Reddam House- Early Learning School

Attic Refurbishment

Heritage Officer Response and layout adjustments
September 2026

Reddam House - Early Learning School
Design Update - Classroom View 1

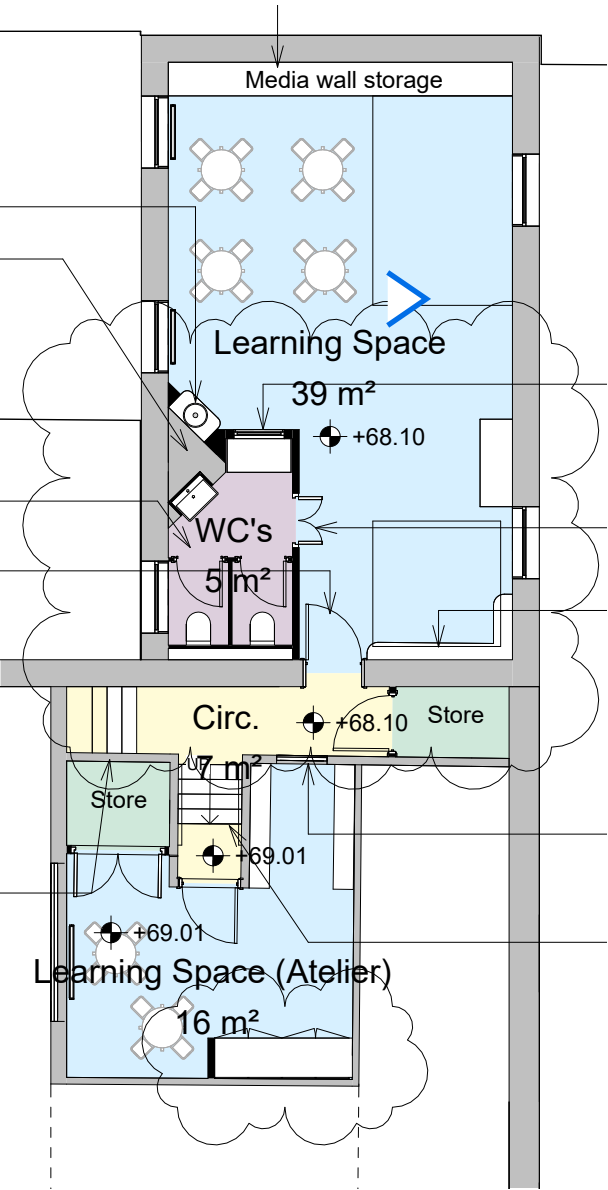
Attic Plan - Adjustments to layout bubbled

1. PORTHOLE WINDOW

Timber frame, S/O Diameter 750mm
Finish: TBC

2. CRAFT SINK BESPOKE JOINERY

Circular ceramic countertop sink
with corian countertop and storage
beneath. Finish and spec TBC.

4.STORAGE WALL BESPOKE
JOINERY

Learning space storage wall with
open cubby shelving at low level
and melamine facias.

Reddam House - Early Learning School
Design Update - Classroom View 2

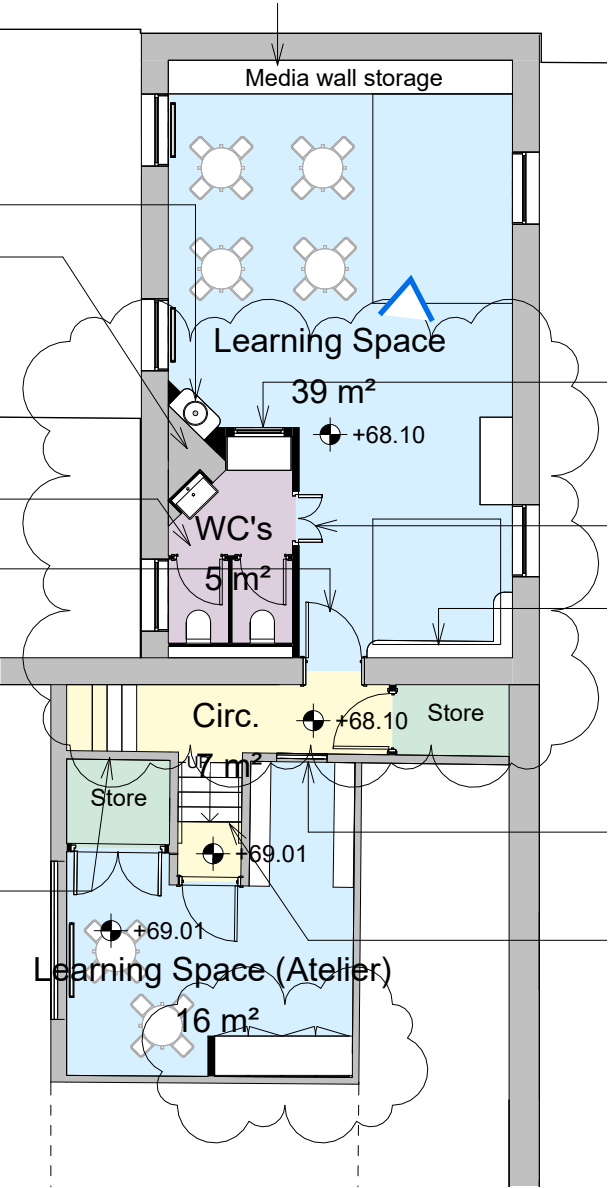
Attic Plan - Adjustments to layout bubbled

1. COAT HOOK BESPOKE JOINERY

Bench with open storage cubbies beneath and coat hook backing panel. Height of bench 340mm.

3. WC DOOR WITH VISION PANEL

Two toned solid door frame with circular vision panel.
Finish: Egger White, Egger TBC

Reddam House - Early Learning School
Design Update - Classroom View 3

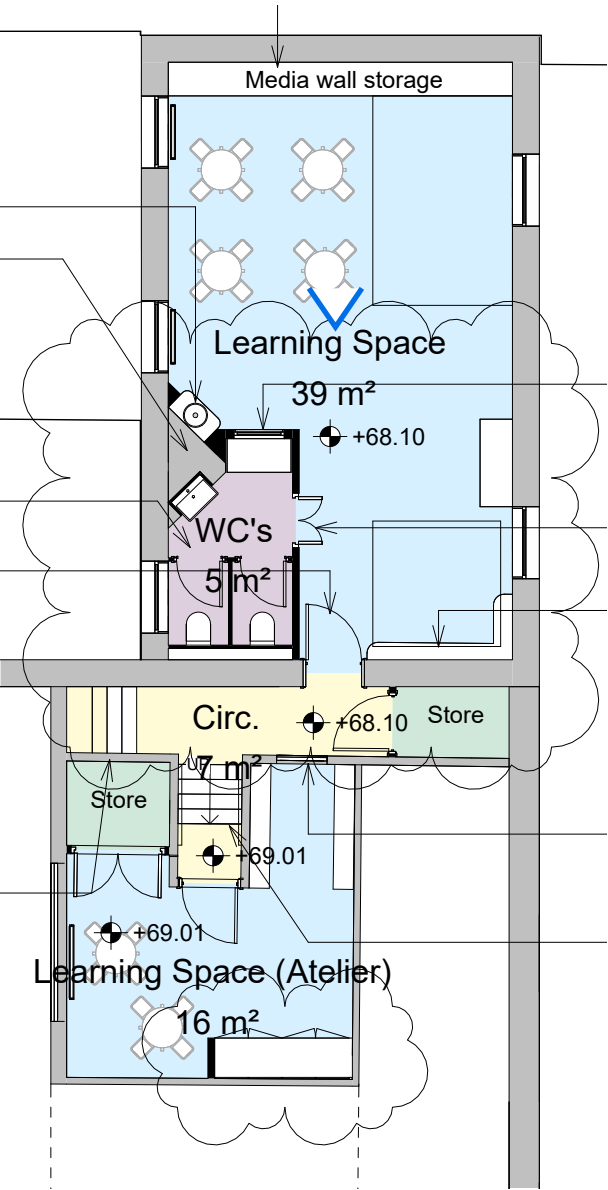
Attic Plan - Adjustments to layout bubbled

1. STORAGE WALL BESPOKE JOINERY

2. PLATFORM BESPOKE JOINERY

Timber platform construction with intergrated backlit box.

Sides finish: Egger Natural Mountain Larch. Carpet finish: Spec TBC

Dimensions 2090x3110x150mm (WxLxH)
